HISTORIC AND DESIGN REVIEW COMMISSION

HDRC CASE NO: 2018-383
ADDRESS: 318 W HOUSTON ST
LEGAL DESCRIPTION: NCB 105 BLK LOT 21 (ALAMEDA THEATER SUBD)
ZONING: D, HE
CITY COUNCIL DIST.: 1
LANDMARK: Alameda Theater Interior
APPLICANT: Michael Ray/Overland Partners
OWNER: City of San Antonio
TYPE OF WORK: Construction of a rear addition
APPLICATION RECEIVED: September 28, 2018
60-DAY REVIEW: November 27, 2018
REQUEST:

The applicant is requesting conceptual approval to construct an addition atop of the existing addition at the rear of the Alameda Theater. The existing addition that will be constructed atop of was constructed in 2012.

① WEST ELEVATION
1/8" = 1'-0" Ref: 1 / A108

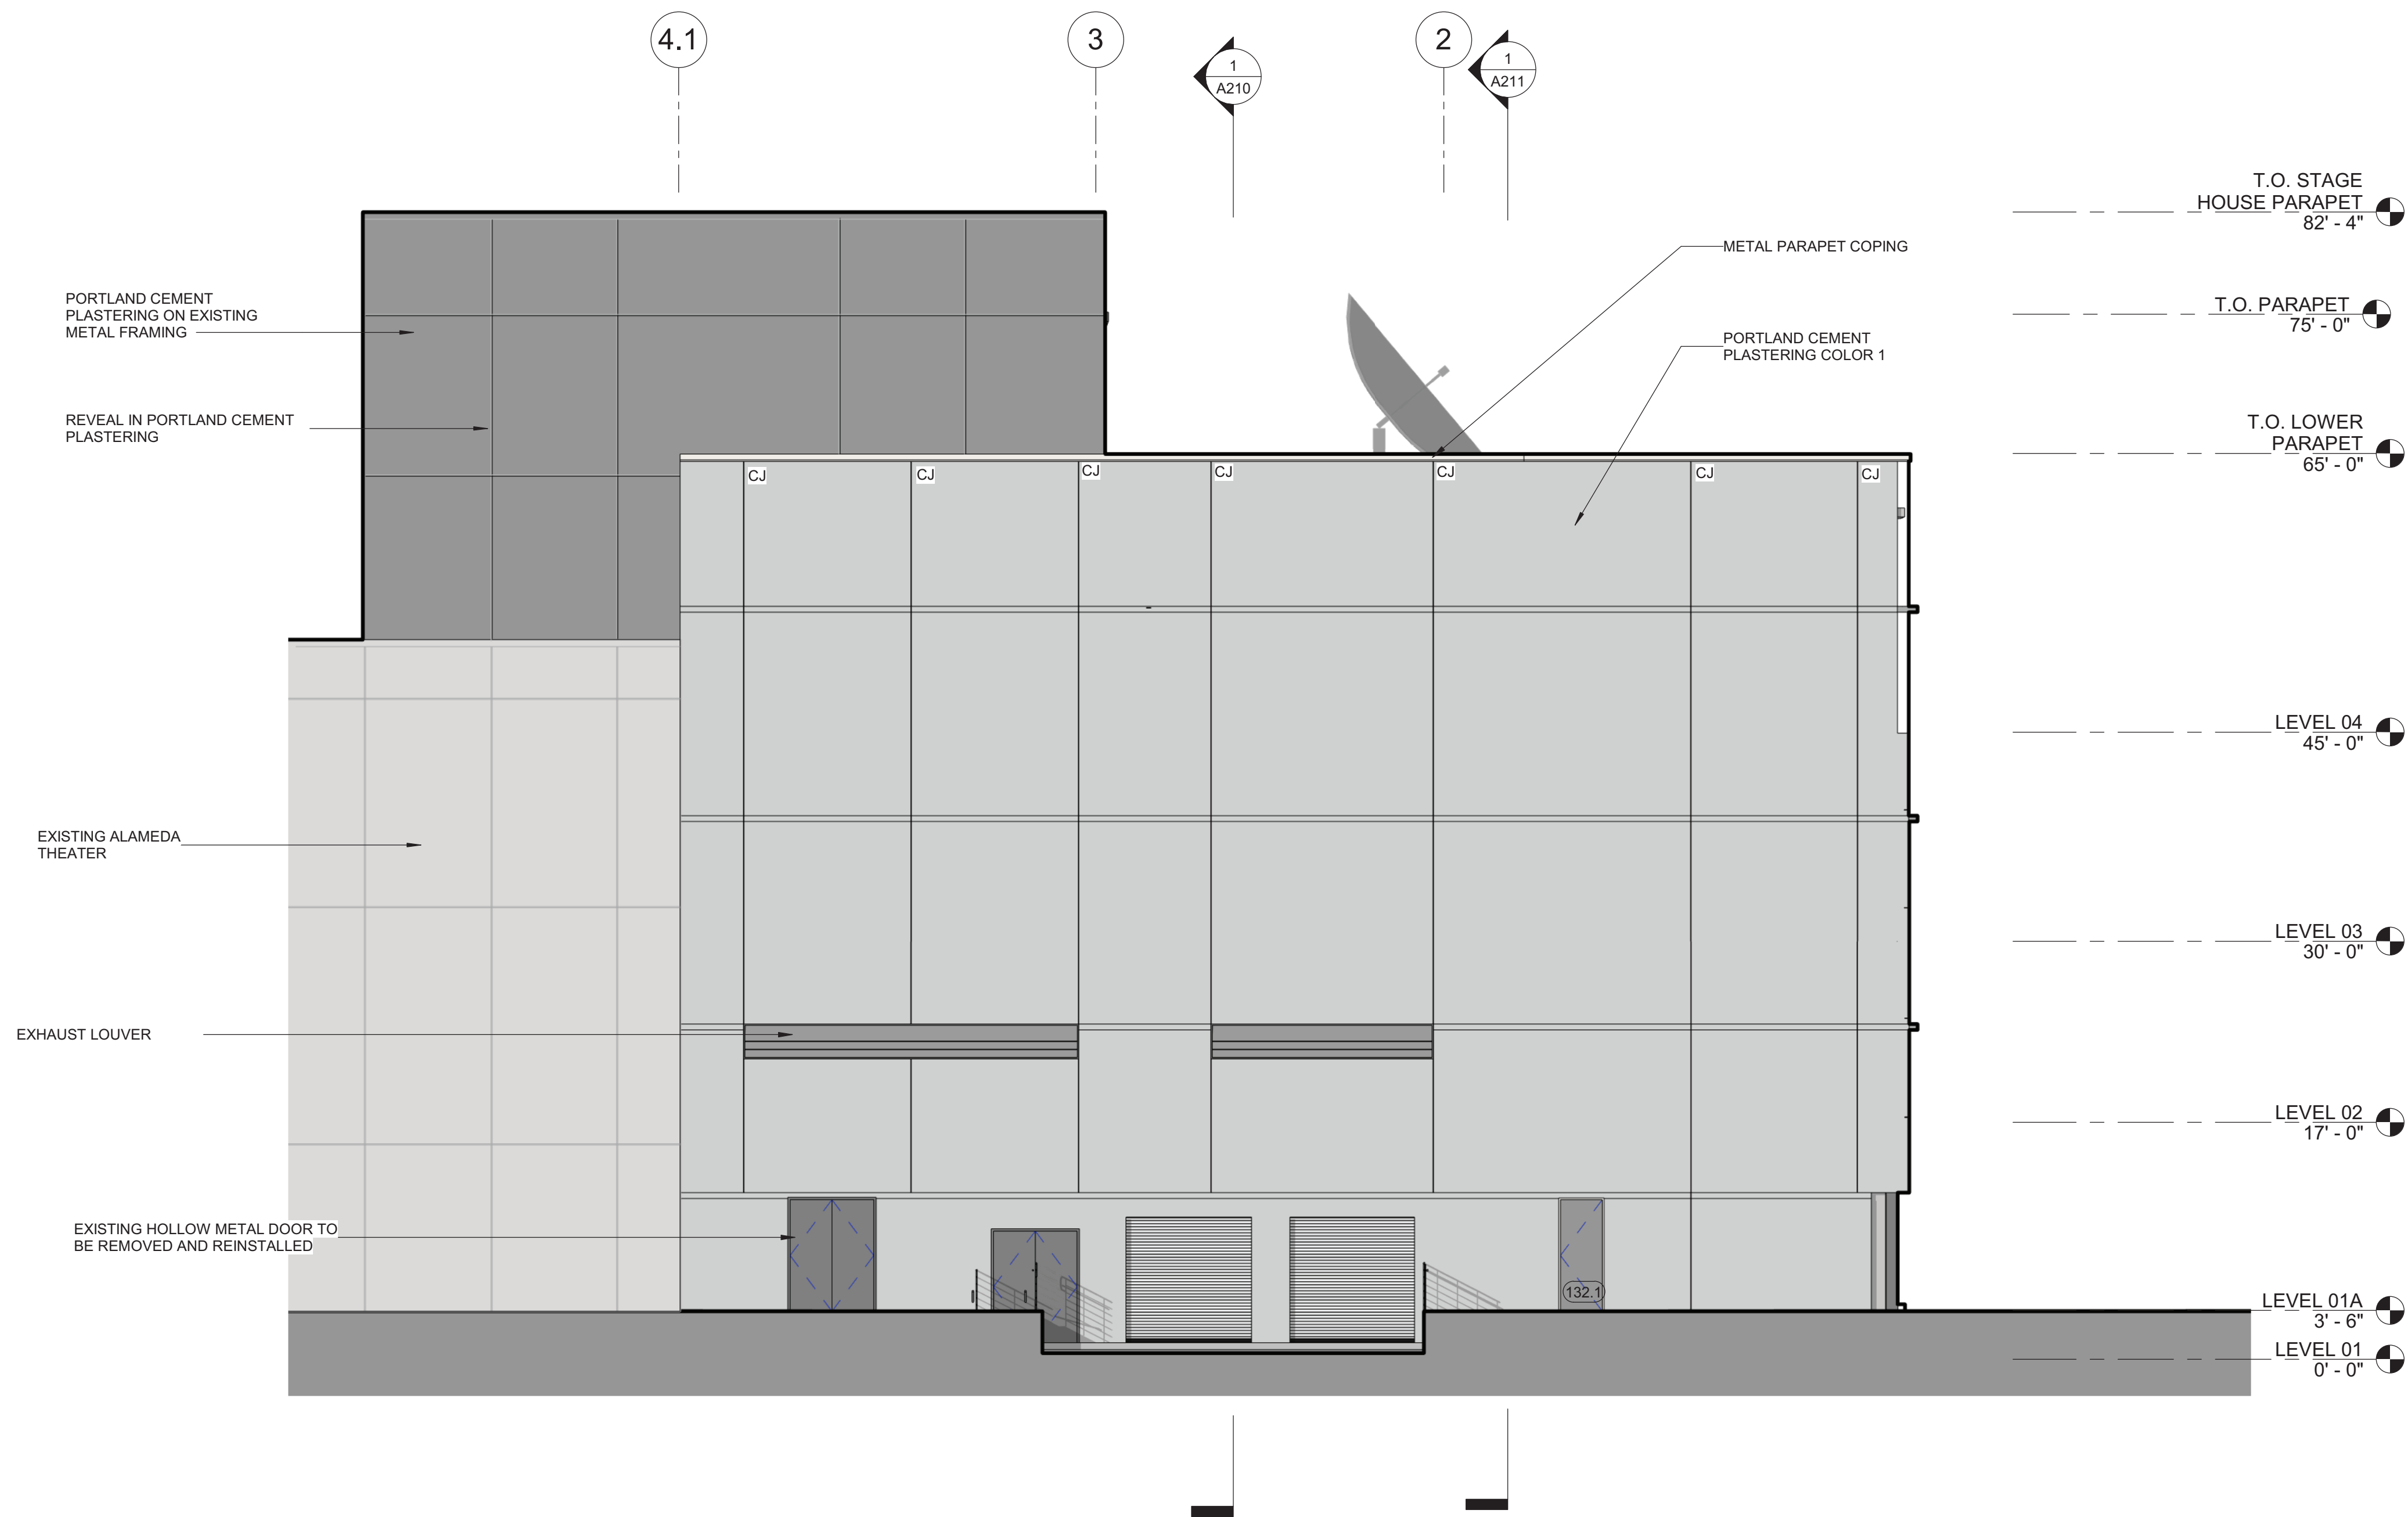
- i. **OVERHEAD ROLLING DOORS** – On the west elevation, the applicant has proposed two, overhead rolling garage doors. At conceptual approval the applicant noted that both doors were to be aluminum. Staff finds the proposed doors to be appropriate given their location on an elevation that does not directly impact the pedestrian atmosphere.

1 BUILDING ELEVATION - EAST
1/8" = 1'-0" Ref: 1 / A110

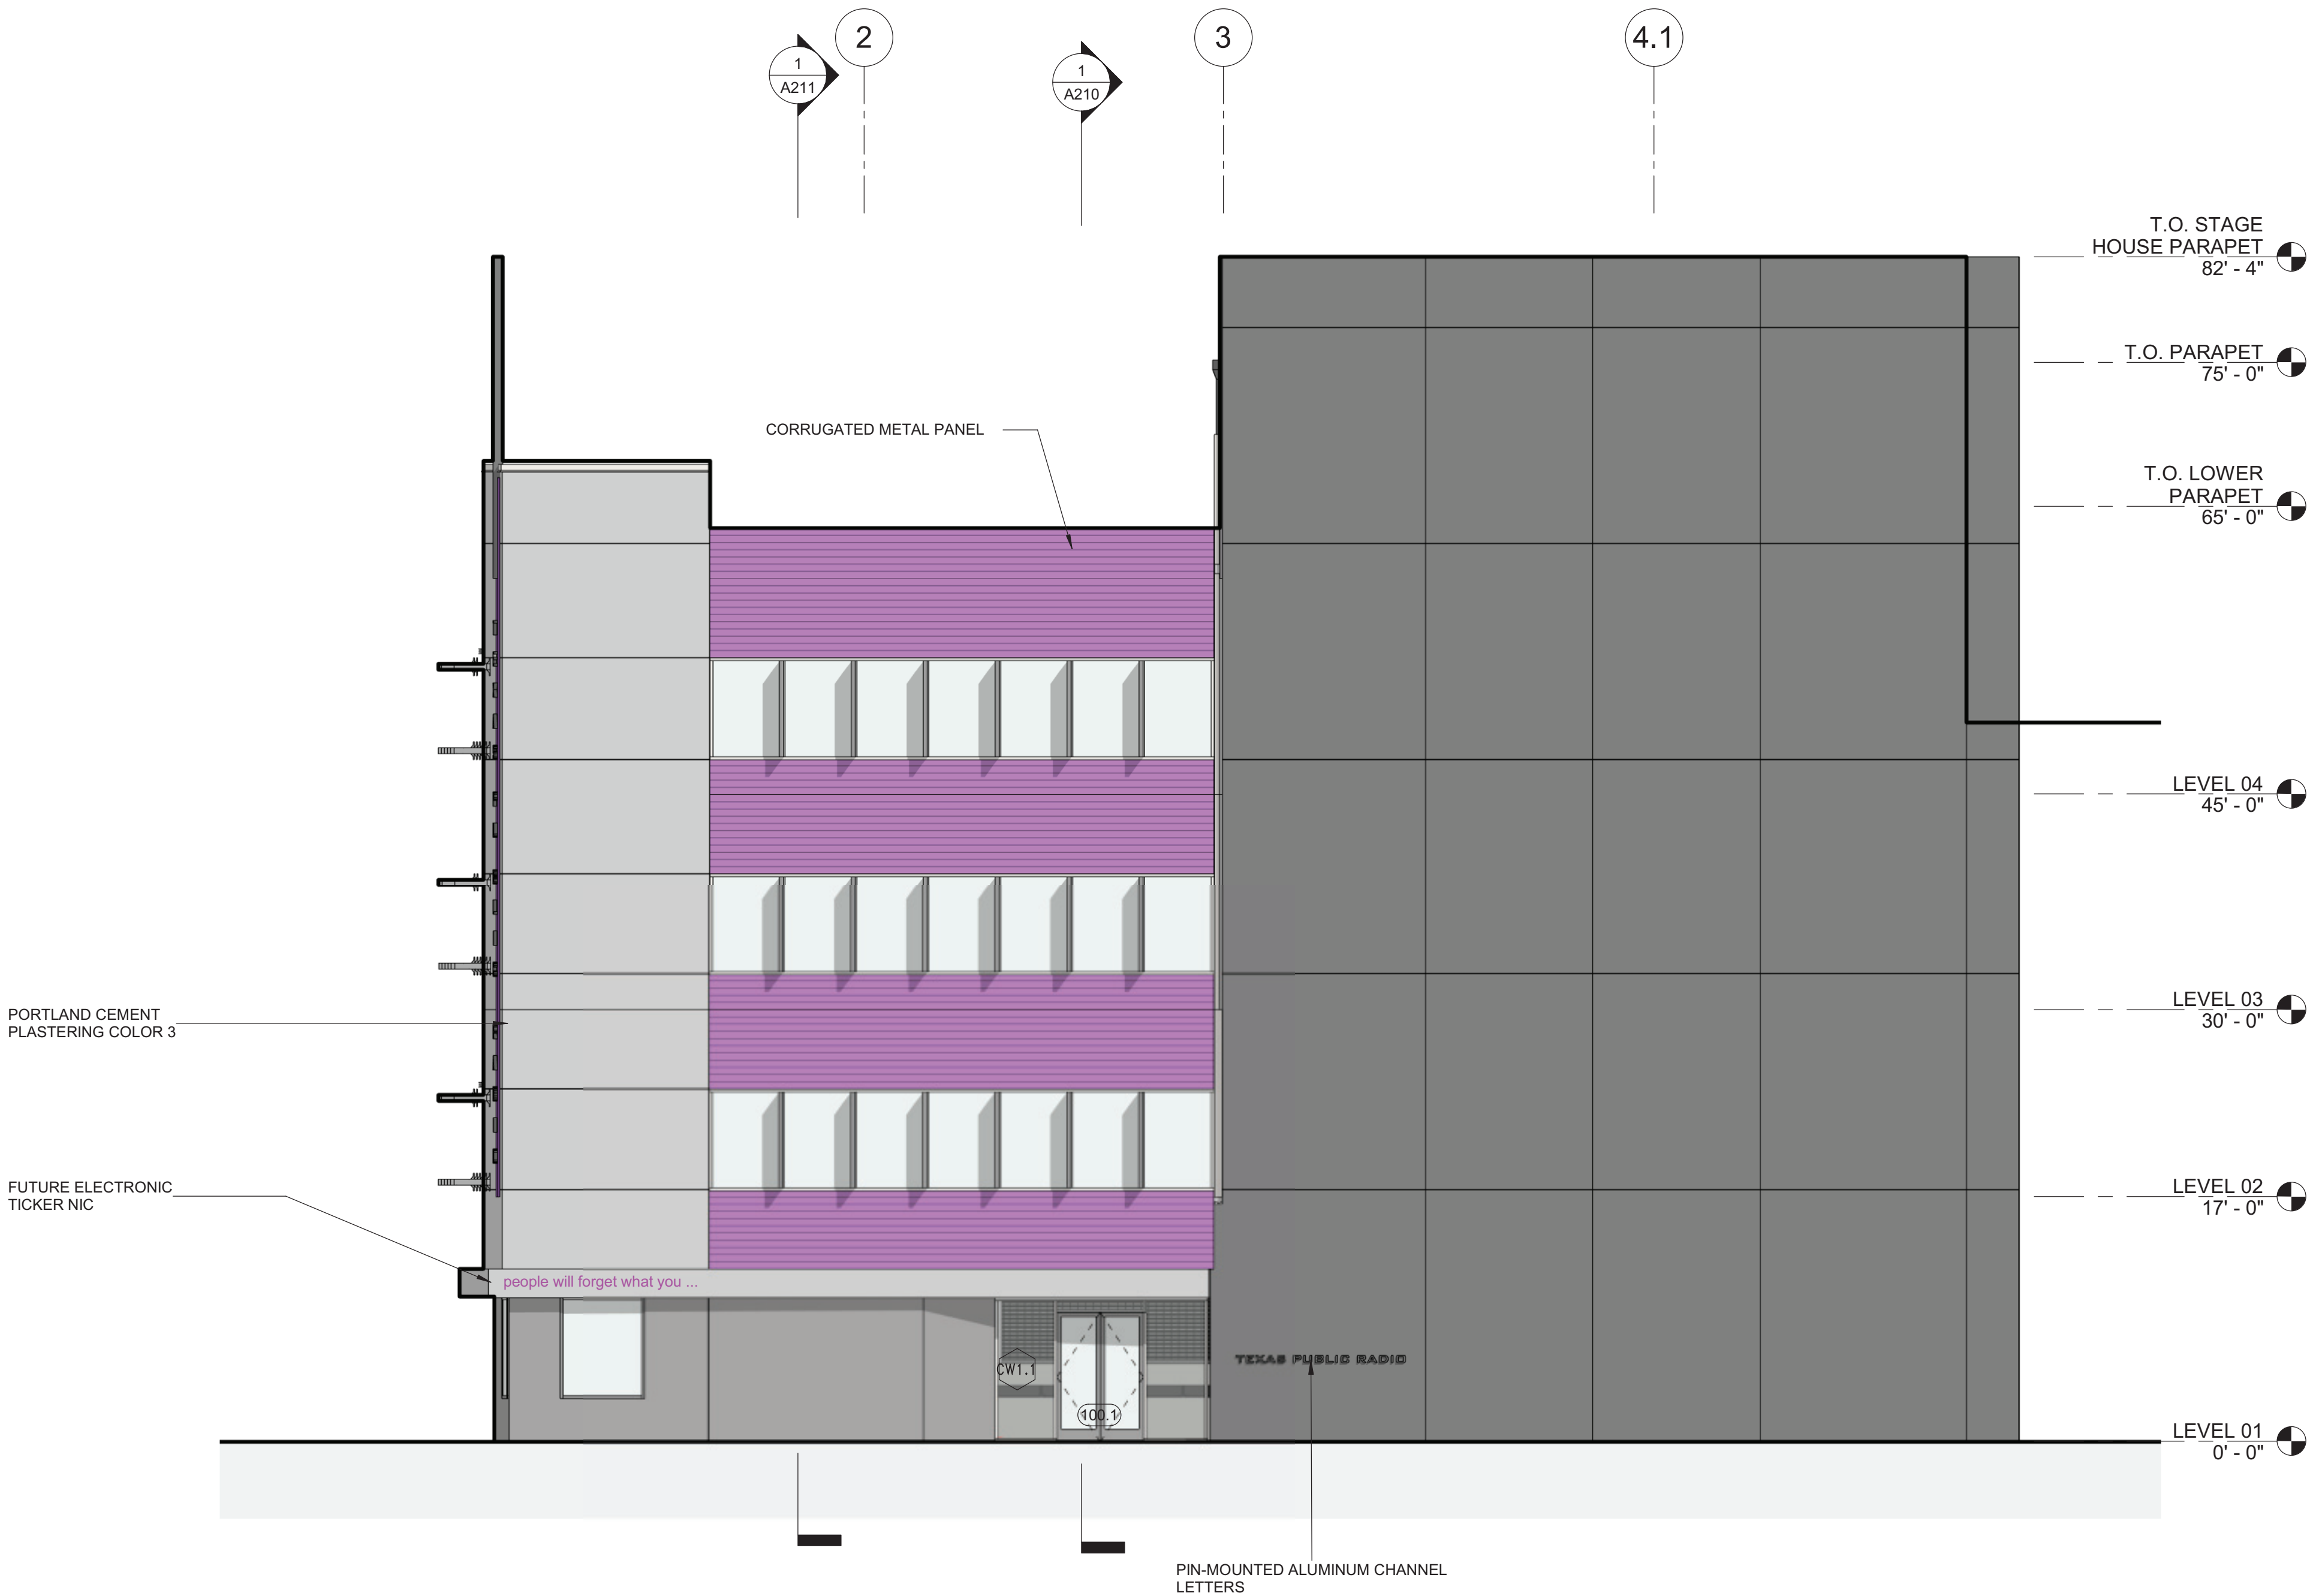
- k. **GROUND LEVEL** – At ground level, the applicant has proposed to install a glazed aluminum storefront system for portions of the façade; however, much of it will feature Portland cement with no fenestration. Staff finds that the applicant should incorporate additional fenestration at the southeast corner as well as along San Pedro Creek below the proposed canopy. The curtain wall systems and storefront system that were proposed at conceptual approval were appropriate. Staff finds that a return to the previously proposed amount of fenestration would be appropriate.

CF: CONCERNS REGARDING LONG, BLANK WALL THAT HAS HIGH VISIBILITY FROM CREEK; POOR VISUAL APPEARANCE.

- i. That the applicant incorporate additional fenestration at the southeast corner as well as along San Pedro Creek below the proposed canopy as noted in finding k.
